ADDENDUM NO. 1

Job No. F70C616E
SAND ISLAND STATE RECREATION AREA
SEWER SYSTEM IMPROVEMENTS
PHASE 2: PUMP STATION 3 RELOCATION & FM 3 REPLACEMENT
Honolulu, Oahu, Hawaii

02/22/21

PLAN: FORCE MAIN 3 - 5
SCALE: 1" = 20'

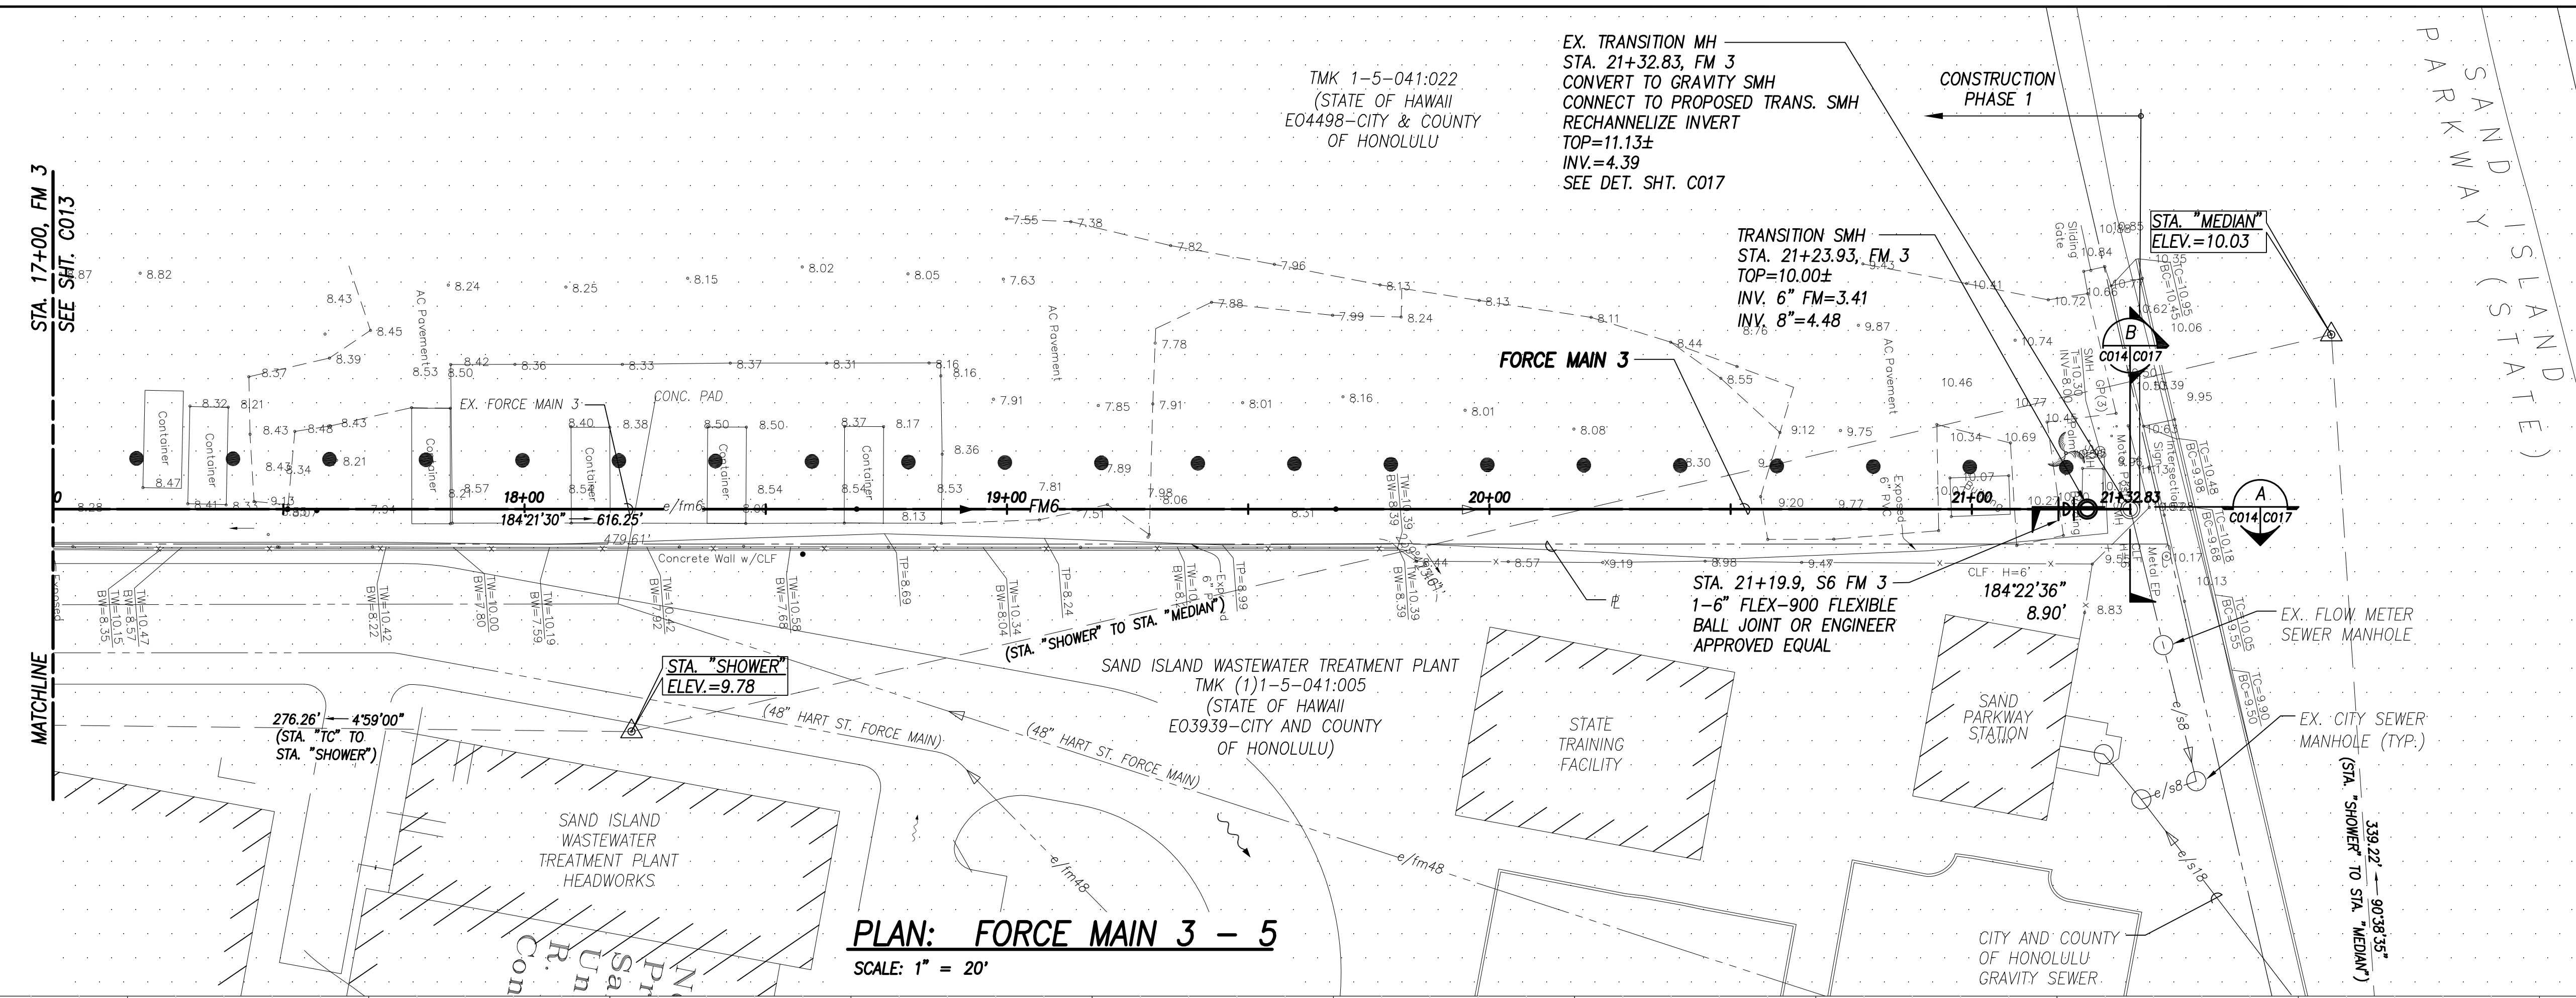
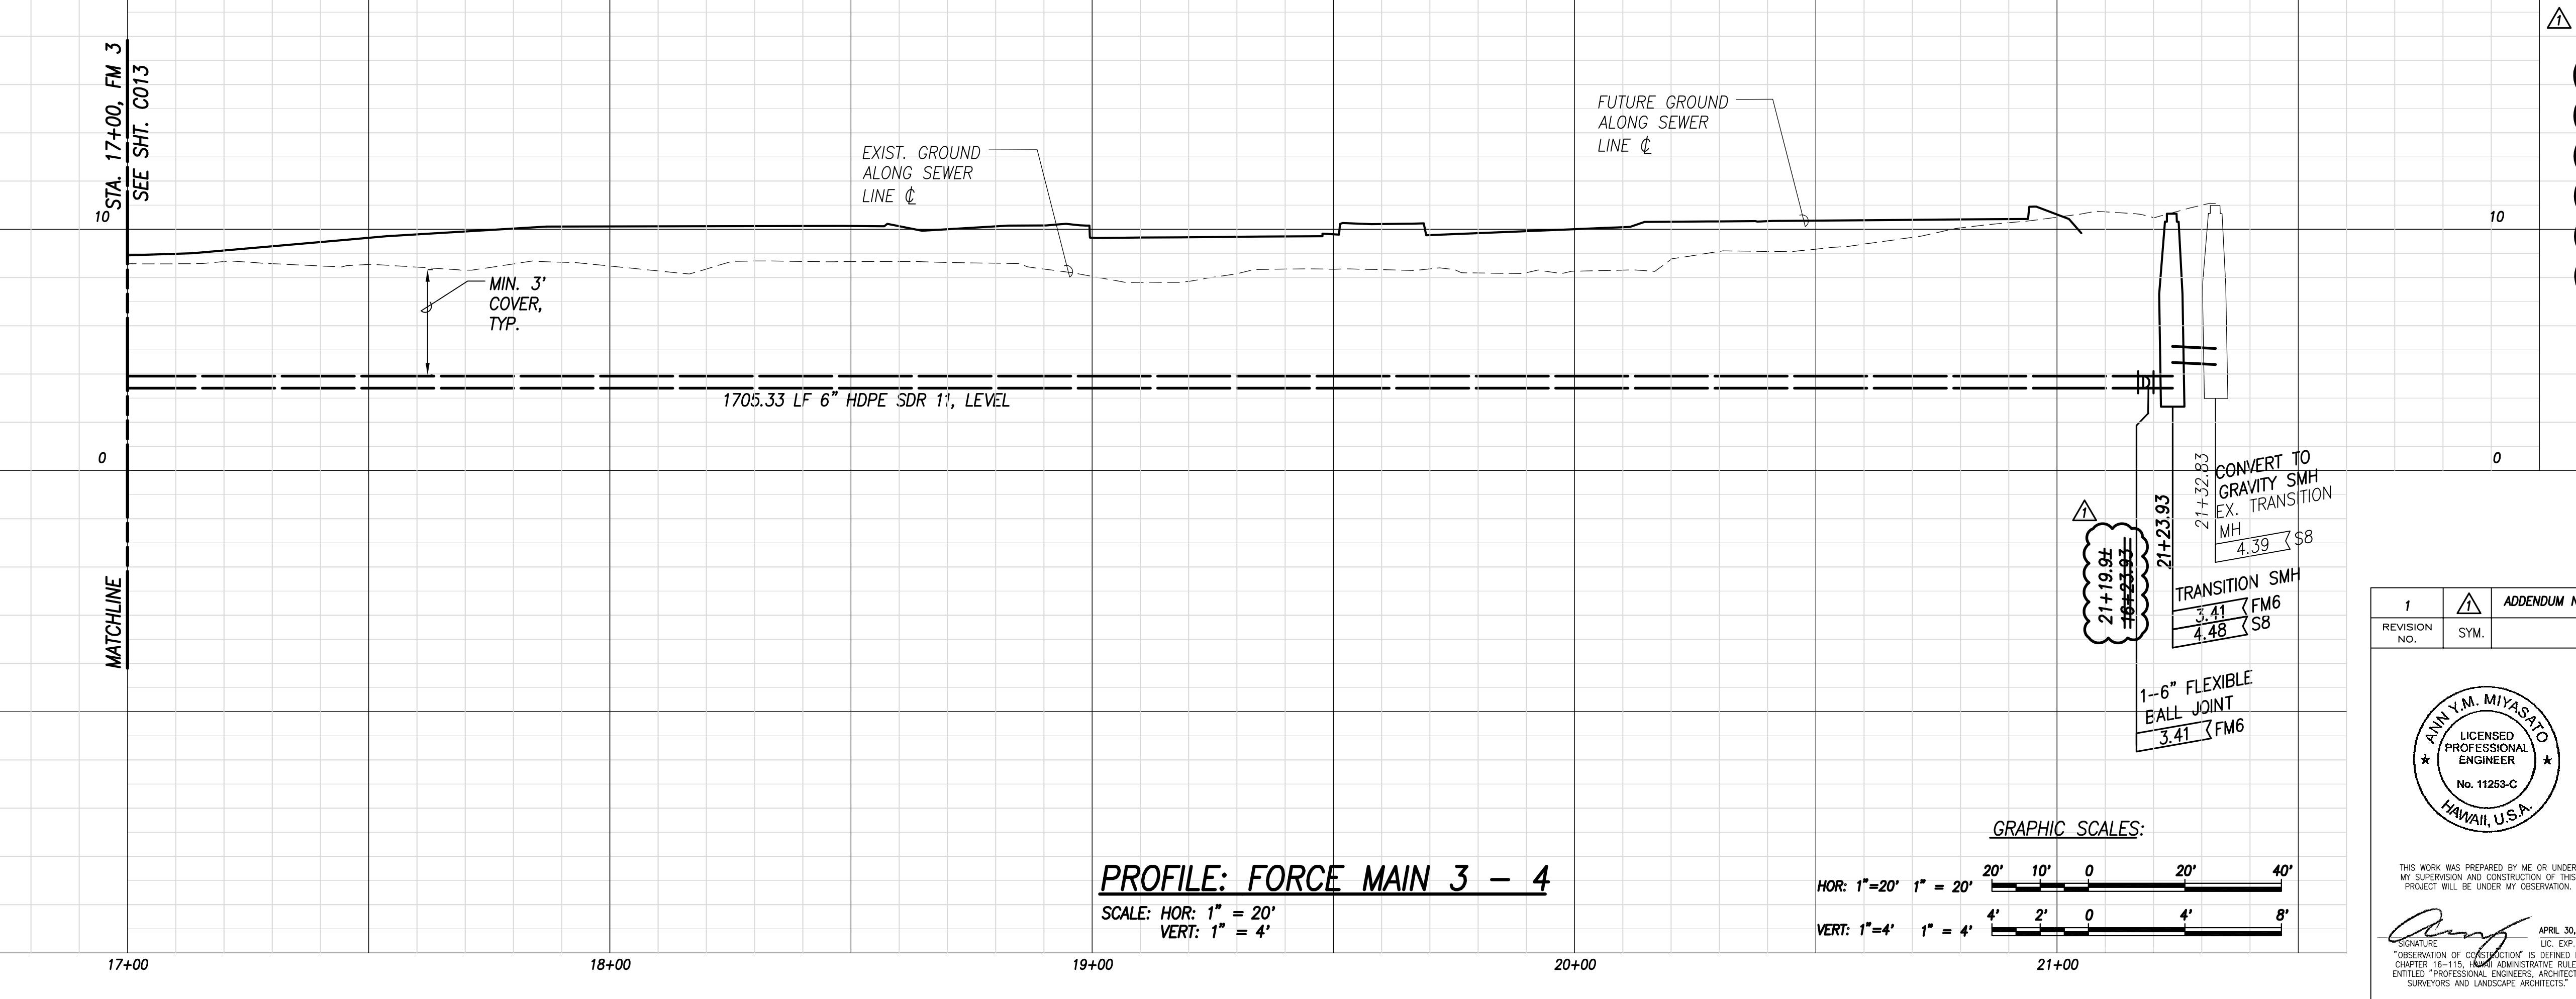
9. Sheet C014, “Force Main 3 Plan and Profile – 5.”
- a. Revised stationing for flexible ball joint to “21+19.9±”
 - b. Removed Note #1, “Contractor to provide continuous sewer service.”

- c. Removed Note #2, “Contractor shall restore all disturbed areas back to original condition or better.”
 - d. Removed Note #4, “Contractor to verify if any containers buildings, etc. within new FM alignment needs to be relocated and /or demolished. All cost incidental to project.”

- e. Added Note #5, “EO area for Phase 1 to be shared by various contractors, Contractor shall coordinate with concurrent and future projects. See sheet C005A.

- f. Added Note #6, “Contractor does not need to restore ground cover after backfilling trench for Construction Phase 1.”

- g. Added Note #7 “Contractor must complete Phase 1 work by June 7, 2021.”
- 10. Sheet C015, “Miscellaneous Detail – 1”
 - a. Added “Gravel Area Detail.”
